Year 1 Monitoring Report

APPLE VALLEY PROJECT

NCDMS Project #100063 (Contract #7531)

RE: Apple Valley Site: Year 1 Monitoring Report

2021 Apple Valley GW6

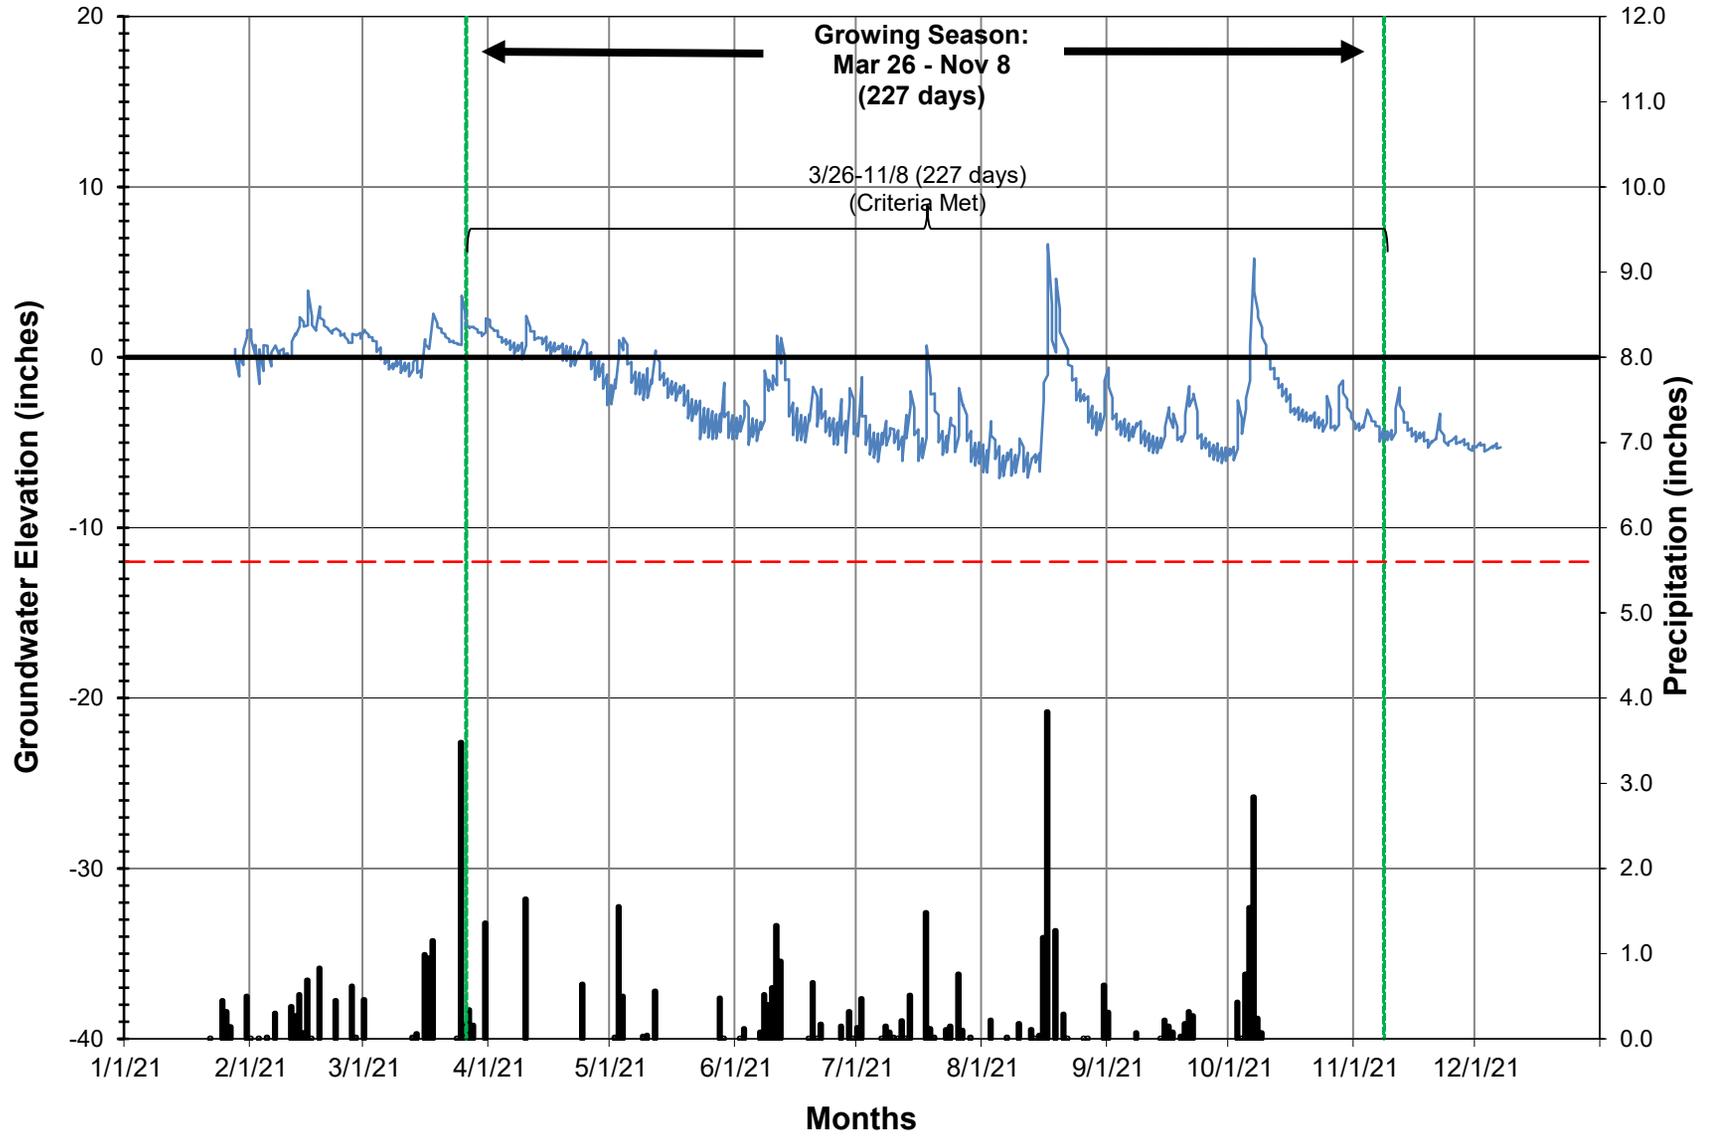
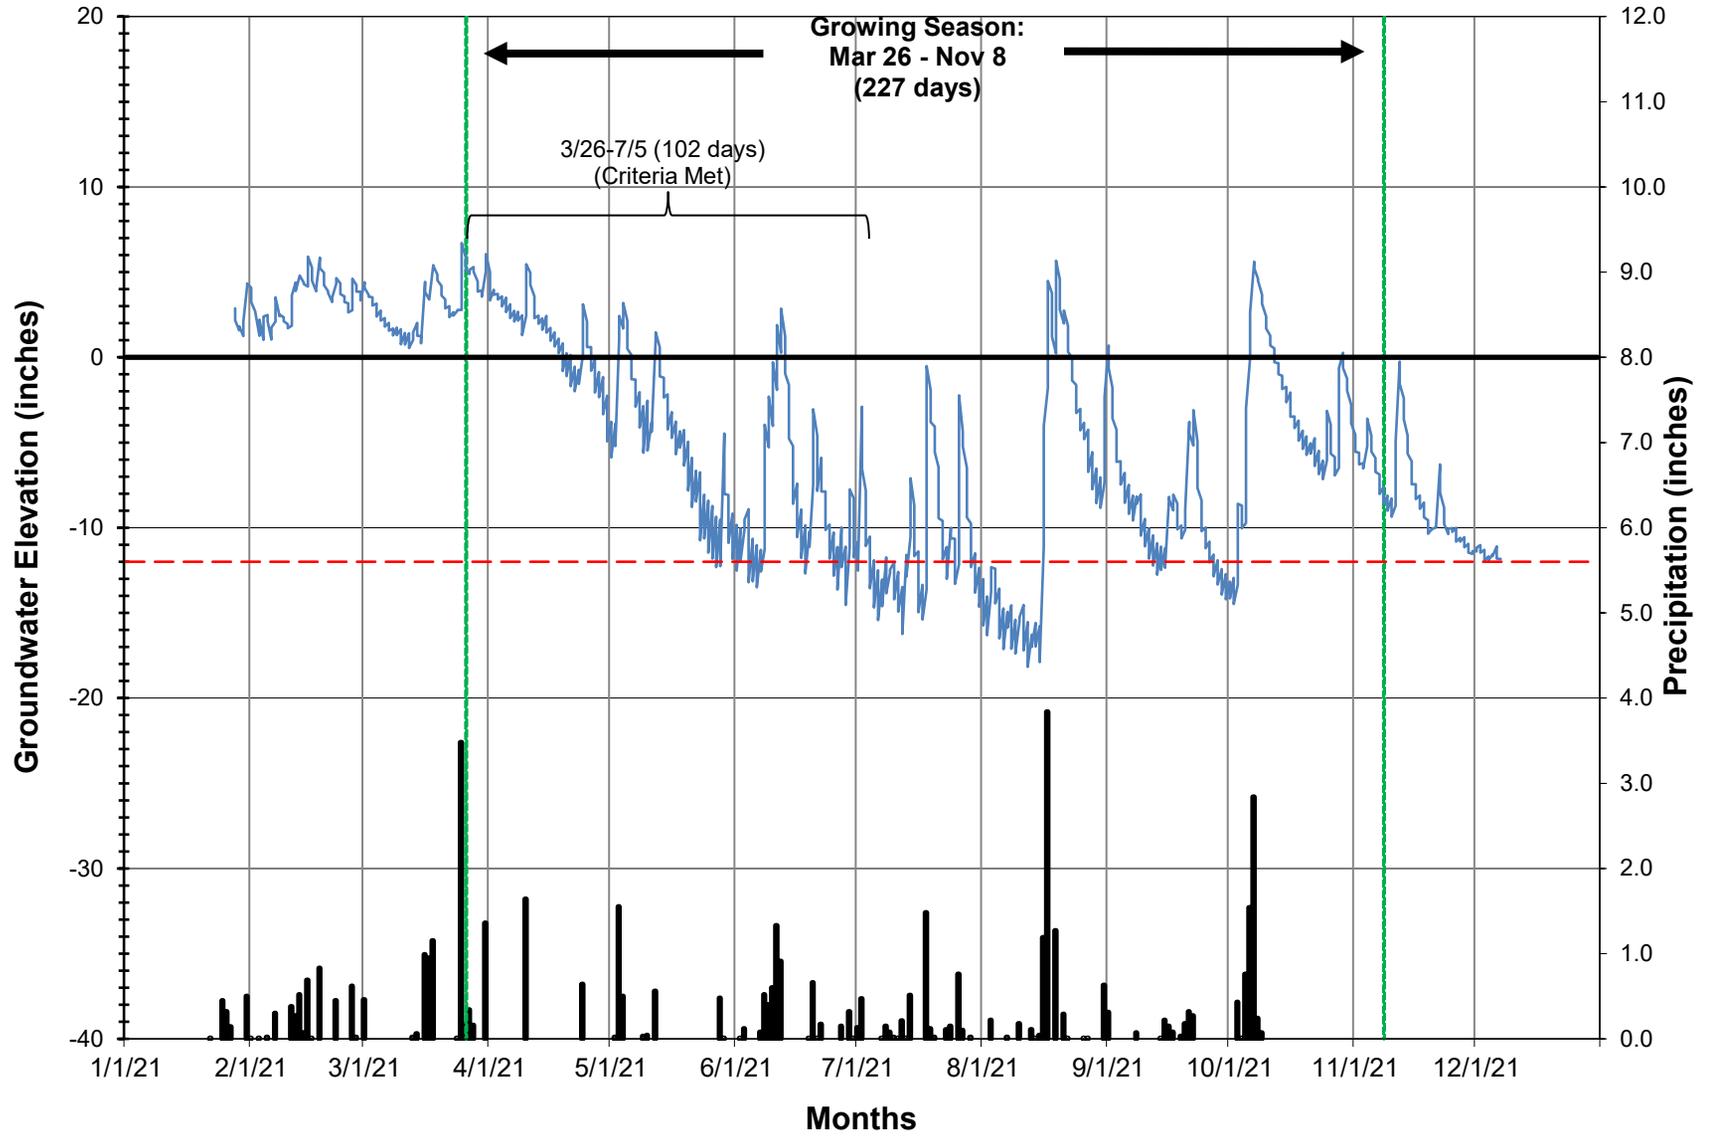
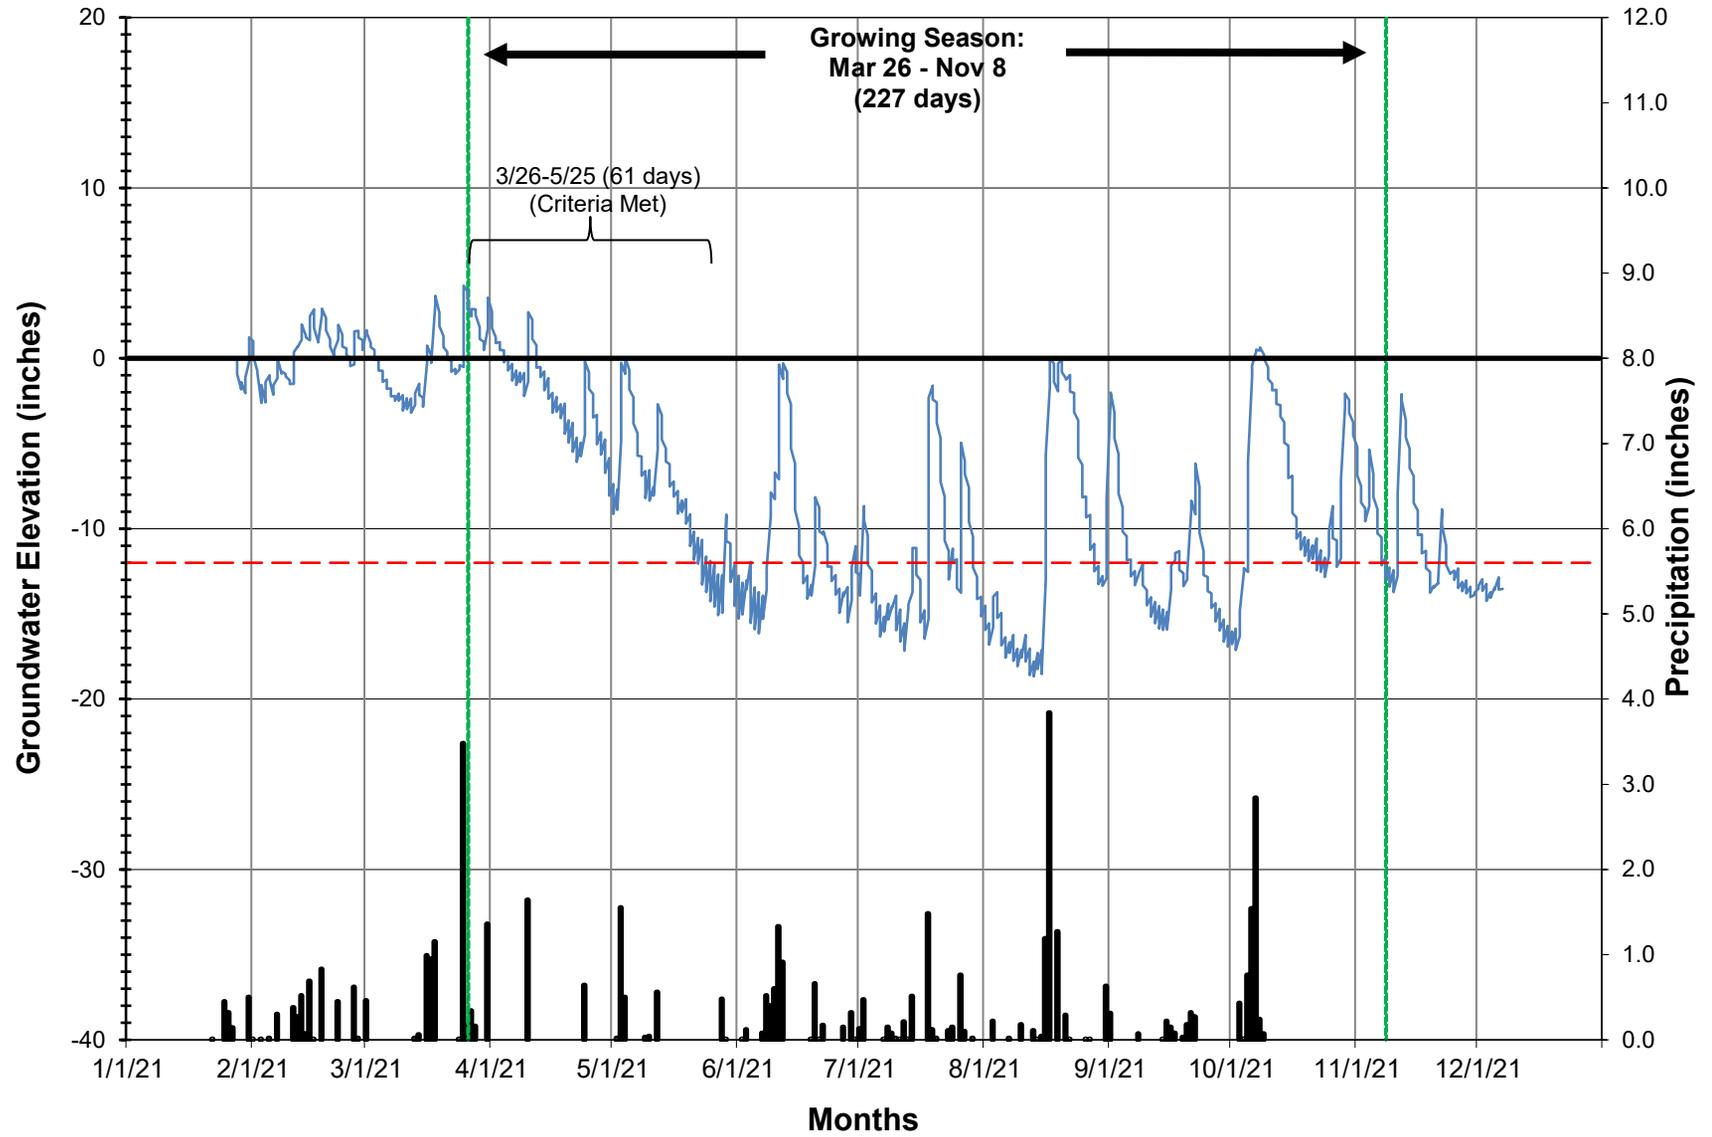
On the GW gage graphs – It would be helpful to show a few more details on the graphs. Please indicate which line is the criteria level. It appears to be a similar line style as the rain levels. Also, it would be helpful to list the date of the growing season on the graph, and during which maximum period the criteria were attained, or that criteria were not attained; and other notes as needed.

The criteria level (Jurisdictional Water Table) has been depicted with a red dashed line and added to the legend for reference. The growing season dates have been added to each groundwater well graph (Mar. 26 – Nov. 8). A bracketed note with the maximum hydroperiod (with an indication of whether or not the criteria was met) has been added to the graphs.
